January 28, 2015

Re: Frontier Stone, LLC

Requested Response Colin Gordon/DEC Questions

10,000 feet Figure A-1

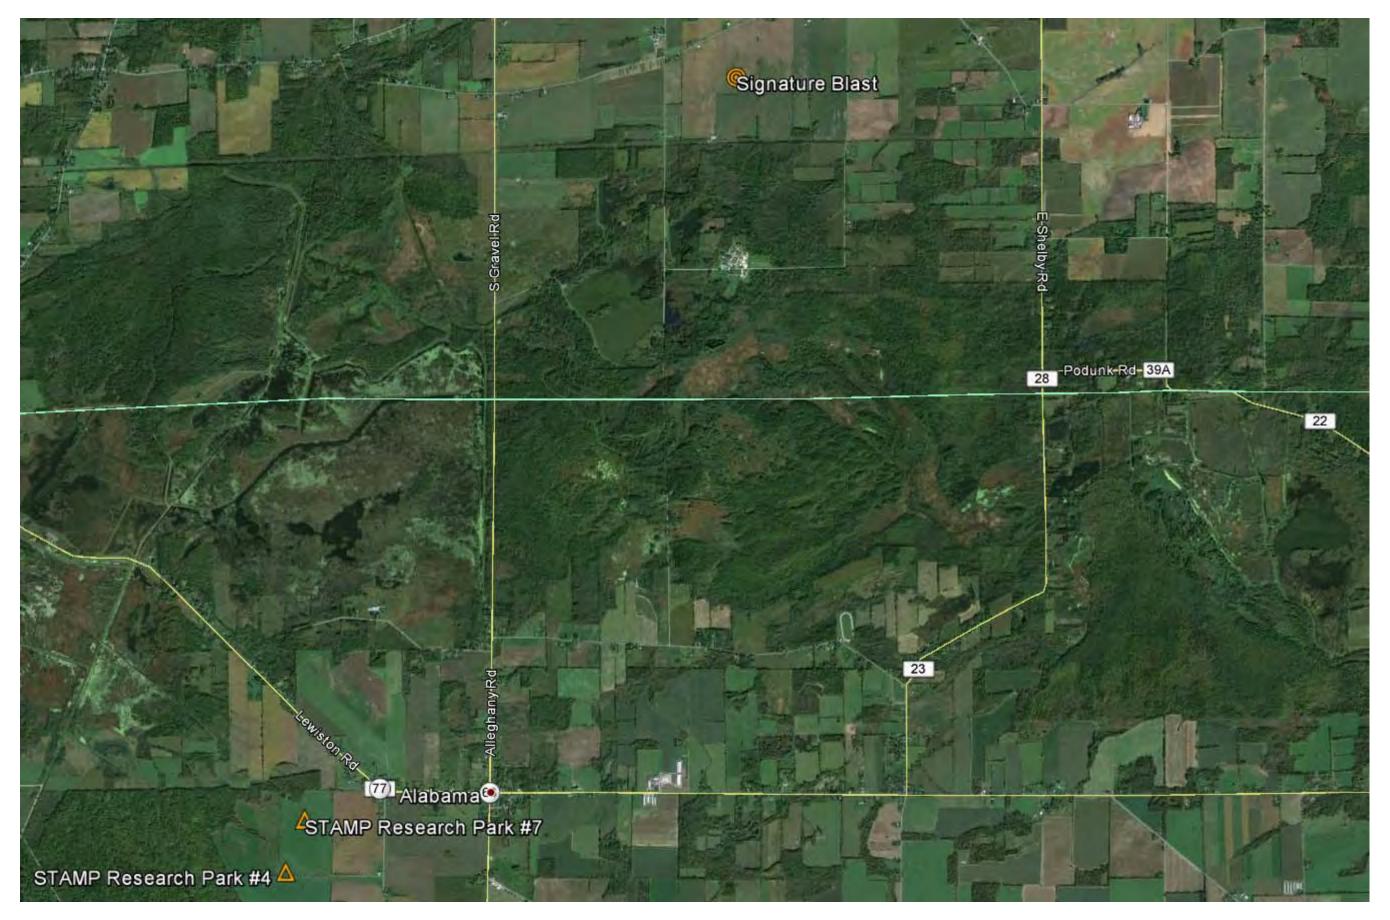
3. Please provide a map which identifies both the quarry and STAMP properties in relation to one another.

See Figure A-1 in Appendix A – Frontier Stone – Figures A-1 to A-14.

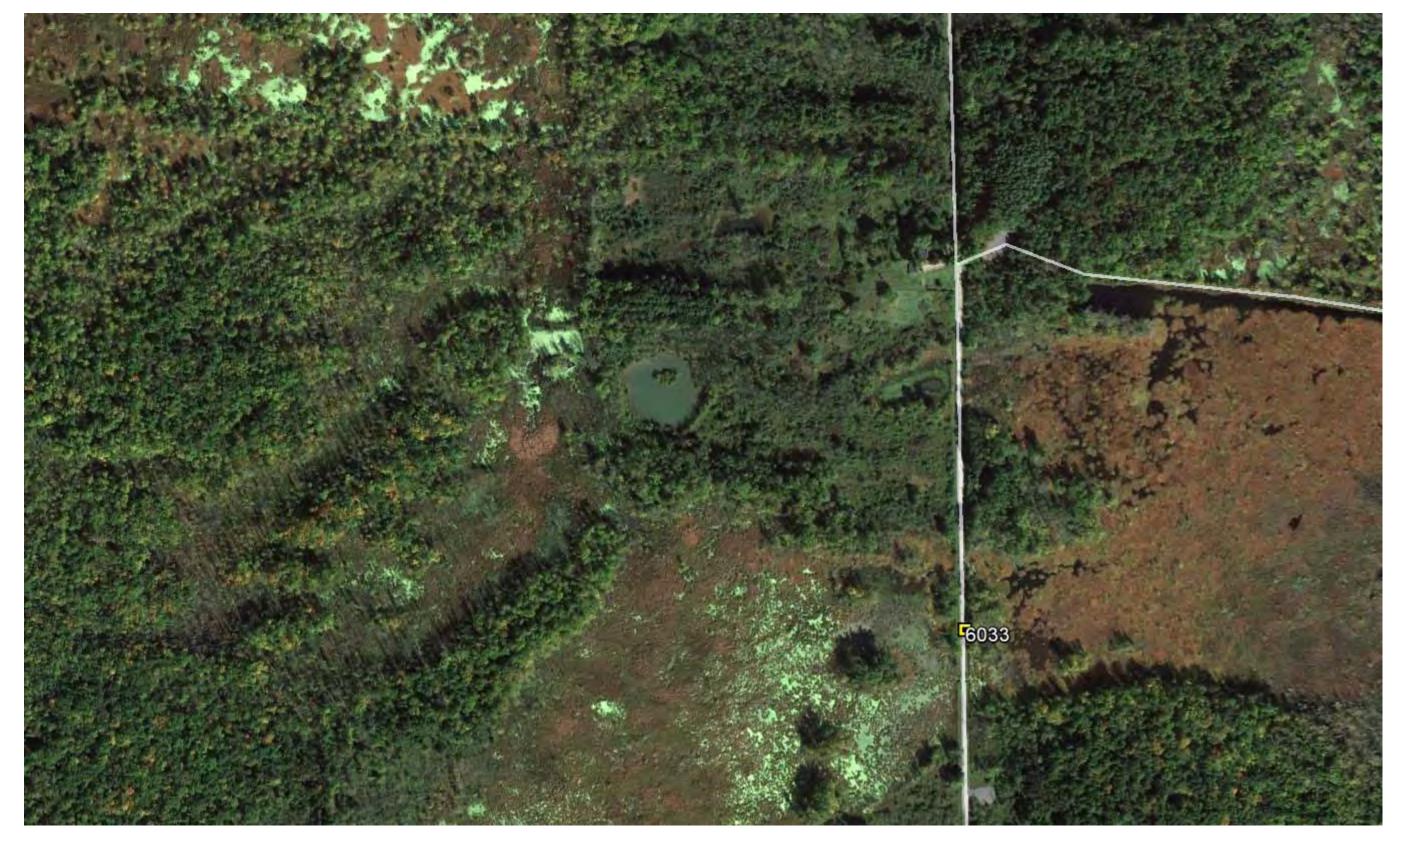
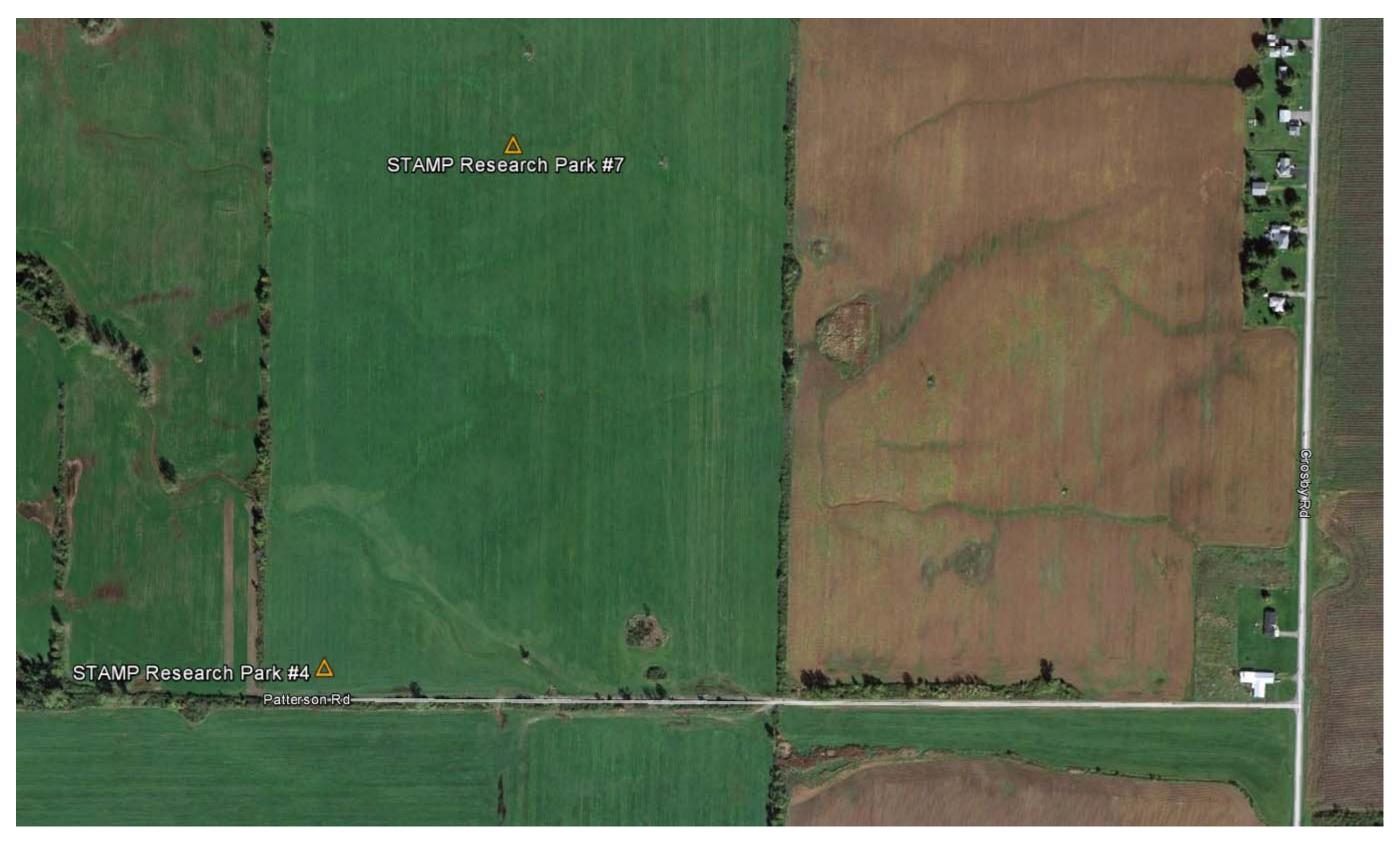
5. Please provide a scaled map which identifies the single hole test blast location, and all seismograph monitoring points used for the study. This can be accomplished by multiple maps, or map inset(s) if necessary.

See Figures A-2 through A-13 in in Appendix A - Frontier Stone - Figures A-1 to A-14.

Figure A-14

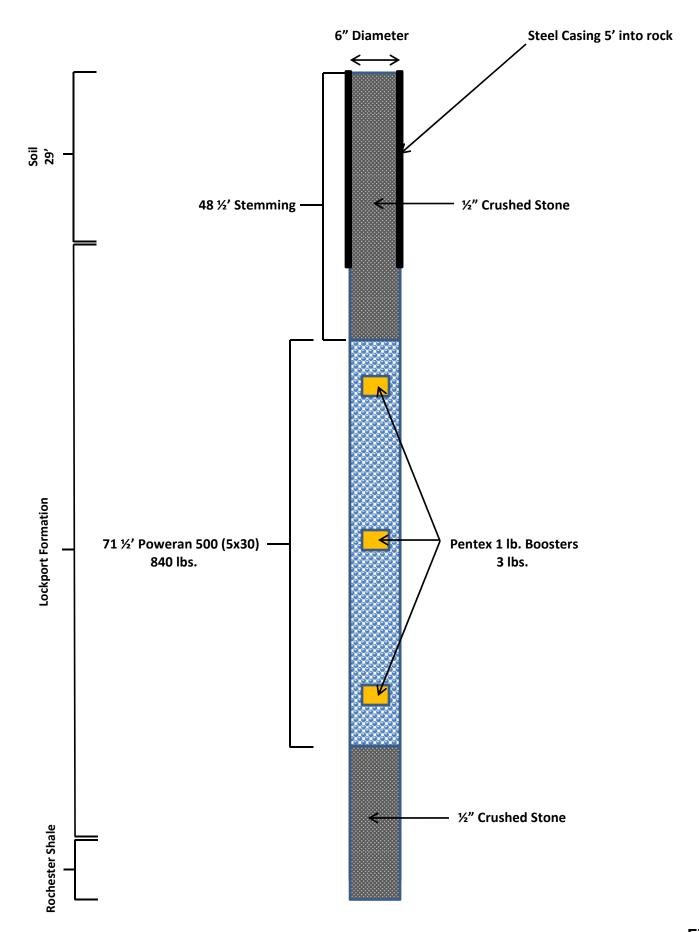
8. Please provide a loading/shot diagram.

See Figure A-14 located in in Appendix A – Frontier Stone – Figures A-1 to A-14.
